June 19, 2013

Audubon has reviewed the “Wildlife Risk Assessment for the Sugarland Wind Project: Palm Beach County, Florida” (September 21, 2012, hereafter “Risk Assessment”) by Normandeau Associates, Inc. The Risk Assessment contains a large amount of work including new information. While Audubon is pleased to find some of our previous recommendations included in these efforts, we are concerned that the proposal still lacks sufficient detail and much of the analysis is flawed; as a result, the Corps cannot adequately evaluate the potential impacts of the project. In fact, the available data suggest the potential for substantial take is high; even with additional data, correct analysis, and an Avian and Bat Protection Plan (ABPP), we fear this project’s impacts will be too great to be permitted. However, this burden of proof belongs to the applicant. Audubon recommends the Corps deny the permit based on the data provided, or defer its consideration until more complete data and accurate analysis are presented to inform this important decision.

Fig.1: Heavy intensity spring migration (pg. 621 Risk Assessment)

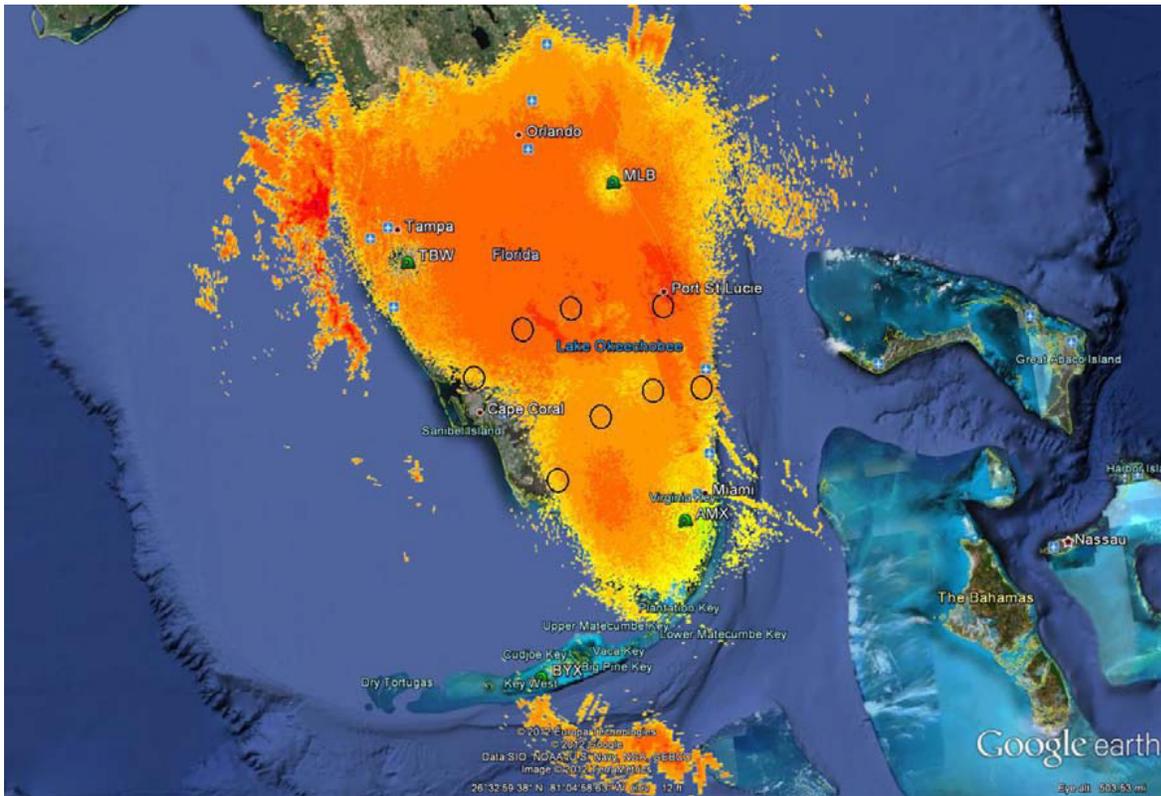
A very important recommendation by Audubon and the USFWS was to include three years of monitoring, which has not been done. Some of the data mining, such as Dr. Pearlstine’s EAA surveys, Kite tracking data, and the NexRad analyses, give multi-year information. However, important site-specific questions such as year-to-year bat numbers and movement, or local Kite activity, remain limited by one year of data. Previously we mentioned variability in numbers of the same species of birds due to myriad factors that make future exposure and mortality difficult to predict. The NexRad radar analysis interpreted migrant mortality as low risk because more birds follow coastal routes. Yet, the radar map on page 621 (Figure 1) shows a heavy migration across the wind farm area, and Figure 2 shows heavy use by migrants of the rotor-swept elevations, reflecting possible episodic events of consequence. Similarly, the Risk Assessment gives (all) Swallows and Swifts a “low to moderate” risk category. What was omitted in the discussion is the mega-flocks of Tree Swallows that winter in this region of Florida, whose estimated sizes are in the hundreds of thousands to millions (e.g., Pranty 2010, 2011, 2012). If one of these flocks enters the wind farm, severe mortality could happen quickly, indicating a risk category greater than low to moderate.

Figure 4-8. Number of targets occurring in each 50-meter increment at the proposed Sugarland Wind Project site, February 11 – March 31, 2012. Red indicates rotor swept heights, and red-blue hashed indicates altitudes partially within rotor swept heights.

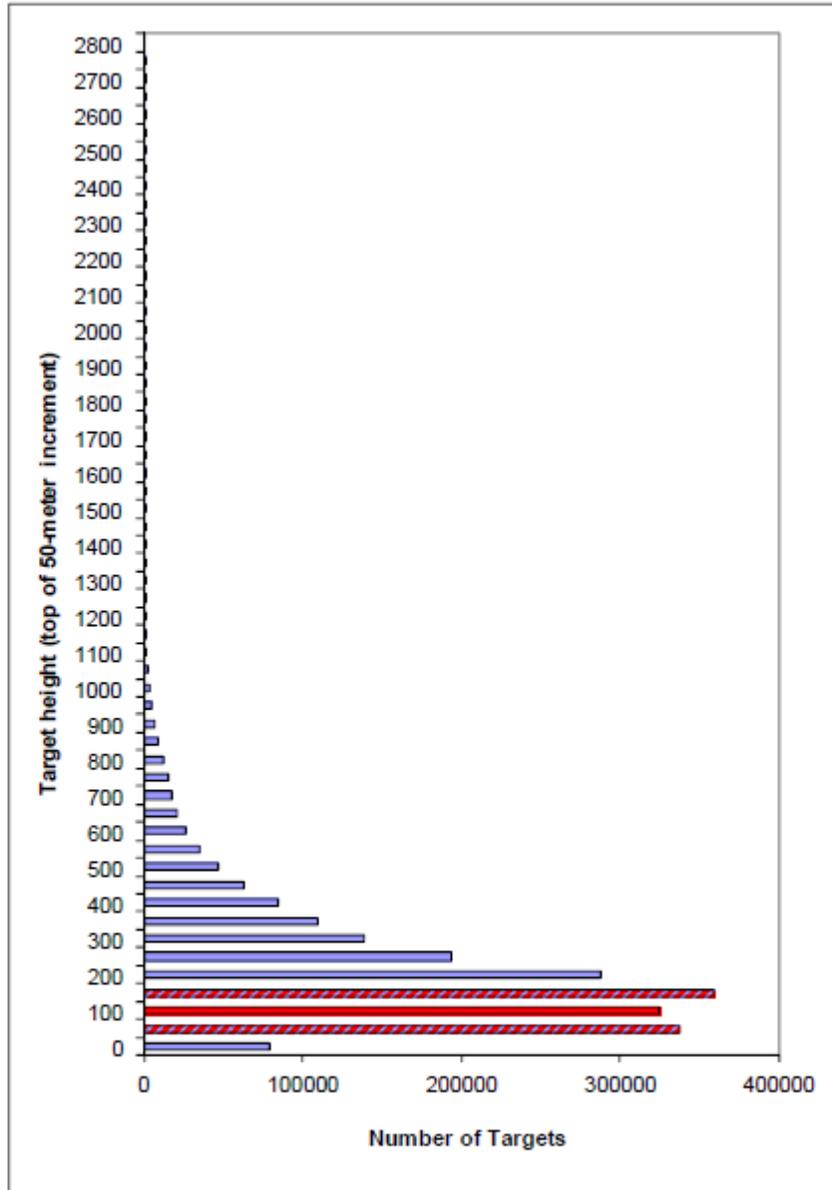
Fig. 2 Of birds detected with radar, the most heavily used elevations are in the rotor-swept zone (reds).
